Service Bulletin	B0402003
	2004-02

Products: All LTH/ YTH/ & GTH Ride Mowers
with Serial Numbers Prior to 092203xxxxxxx

Subject: New Washer for Front Wheel Spindles

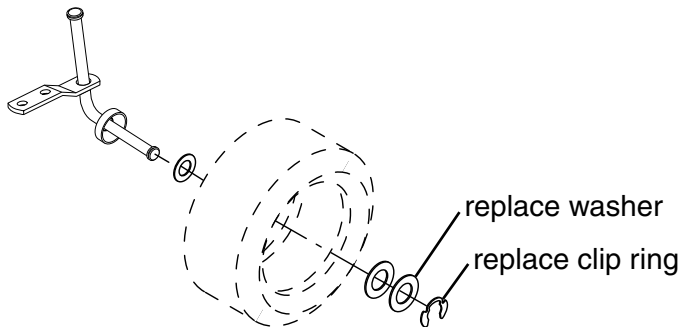
We have found that some original front wheel spindle washers on these units are too soft. This can cause the washer to become deformed due to rubbing from the clip ring and could eventually cause the clip ring to fall off.

A new hardened washer has been developed that solves this problem and was implemented into production on 9-22-03.

If you encounter this problem on units in the field or if you have unsold inventory of the affected tractors, please replace the original outermost washer (silver finish) on both the left and right sides with the new hardened washer (black finish). As a precautionary measure, you should also replace the clip rings. Warranty time allowed for this update is 18 minutes.

NOTE: Only the clip rings and the outermost washers need to be replaced, reuse the other washers. See the assembly diagram shown below for the type of tractor you are working on.
